CITY OF HENDERSONVILLE HISTORIC PRESERVATION COMMISSION SPECIAL CALLED MEETING

CITY OF HENDERSONVILLE AMENDED AGENDA ITEM SUMMARY PLANNING DIVISION

1015 N Main Street, Siding Replacement, Window Replacement, Rear

TITLE OF ITEM: Addition (25-82-COA) – Sam Hayes / Planner II

SITE IMAGES:

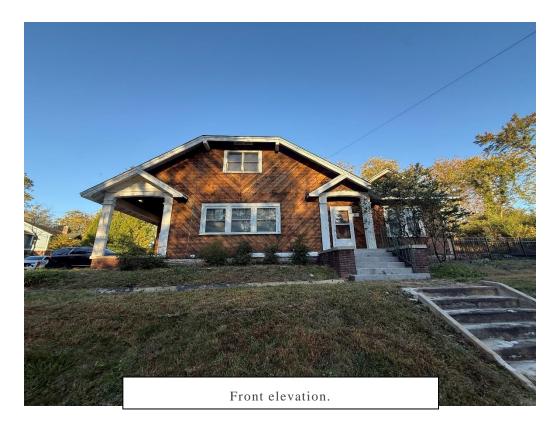
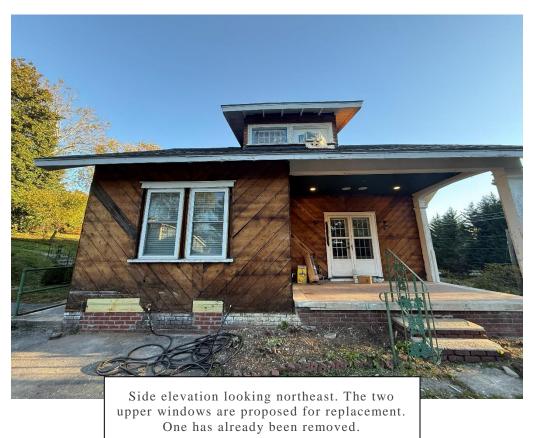
The applicant has already removed all of the original siding off the house. The original siding was wood painted white. The siding formed mitered corners (see photos below). The applicant has proposed to replace the original siding with concrete board siding and concrete board shake siding in the gables.

- Retain previous siding for comparison applicant should provide any siding that may be remaining for comparison with new siding. – Will Bring Example
- Details on the corners of the building should be provided. The original siding utilized mitered corners.

Westchester Aluminum Clad Double Hung/Single Hung Scale

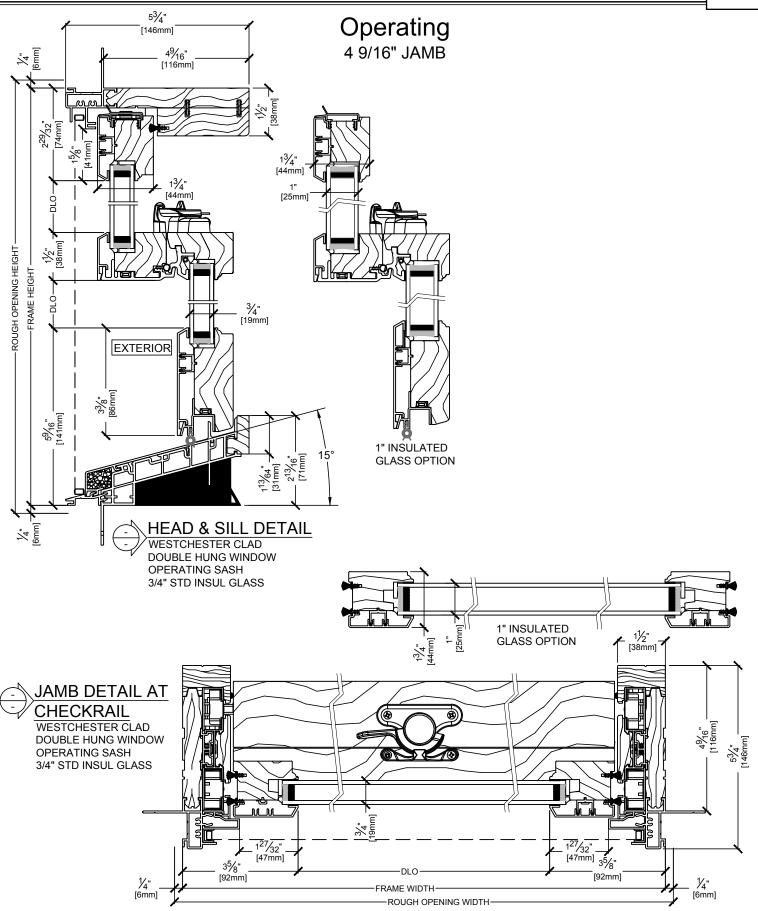
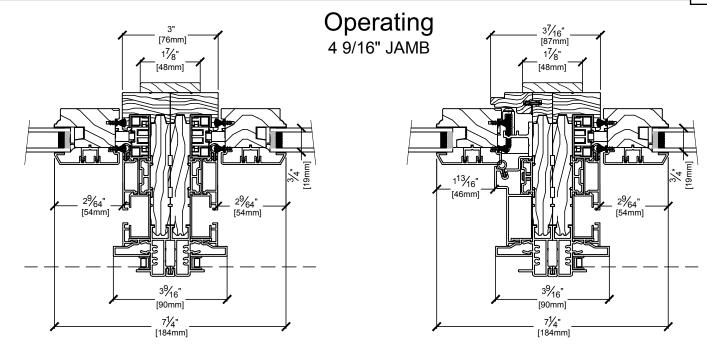
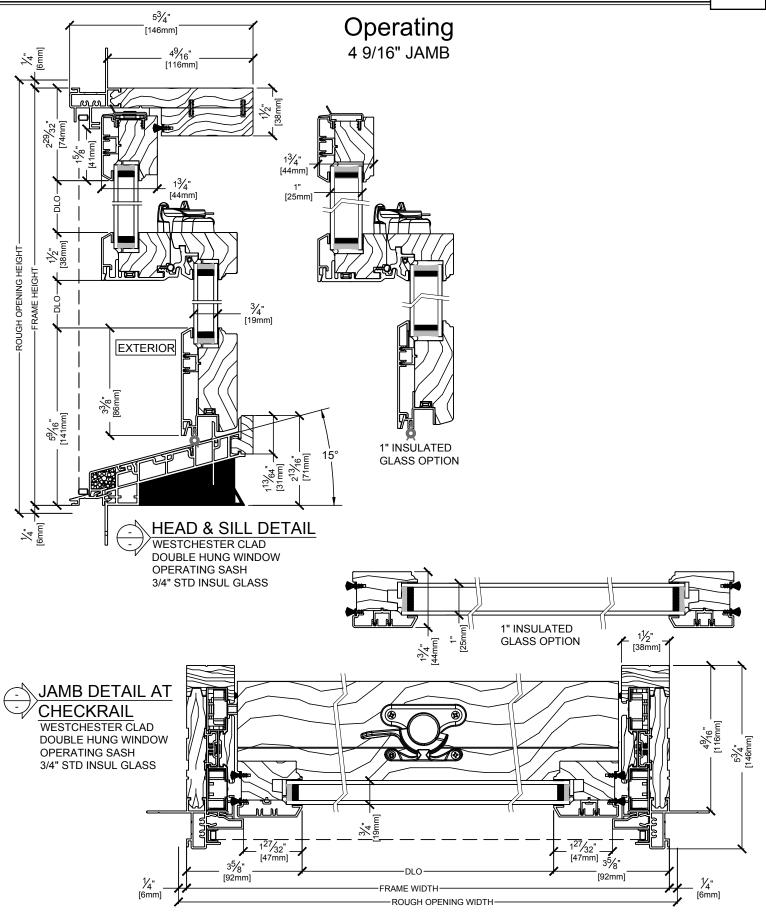
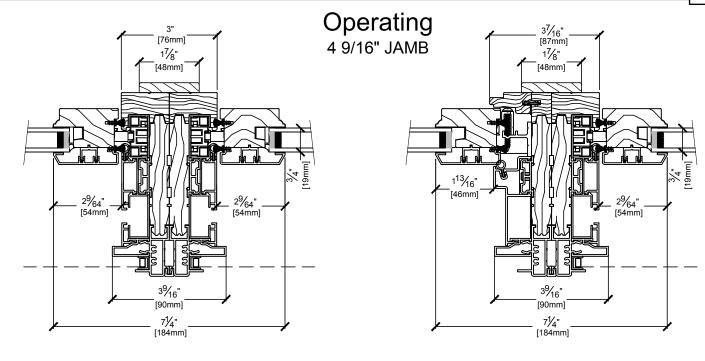
- Muntin's should be on exterior of glass.- Exterior
 - More detailed specs should be provided. What further specs are needed outside of the information provided along with the detail that was provided?

- Siding
- Retain previous siding for comparison applicant should provide any siding that may be remaining for comparison with new siding.
- Design Review Advisory Committee does not support using a substitute material because it will likely change the overall appearance of the house. Use of natural wood that matches the removed siding is appropriate.
- Details on the corners of the building should be provided. The original siding utilized mitered corners.
- Providing a cement board mockup could be useful to see how it would look.
- Windows
- Clarification for new windows
 - How will windows be fit in
 - Will the frame be removed?
 - What is the cladding proposed?
 - Muntin's should be on exterior of glass.
 - More detailed specs should be provided.
